Manufacturing Bulletin

Subject: Micro Networks (MNC) Integration with IDT

Date: February 8, 2010

Figure 1

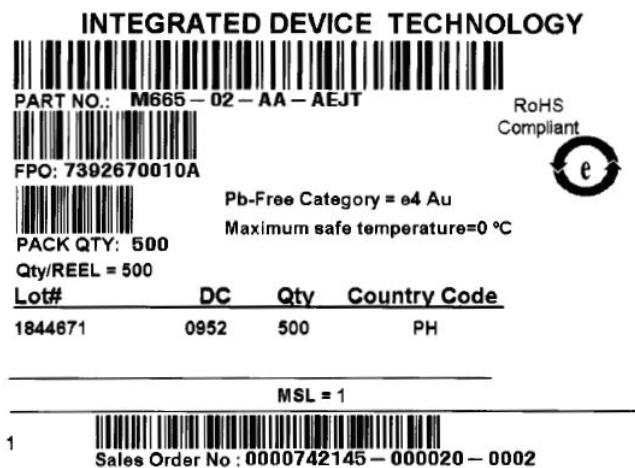
The labels printed for these products must use the IDT barcoding system. The last character of the five digit datecode YYDDD (Julian calendar format) must be truncated to YYDD.

During this transition period, customer may receive shipments using the IDT barcode label system (truncated digit) and the former MNC labels.

0952 (Refer to Figure 1)

0921 (Refer to Figure 2)
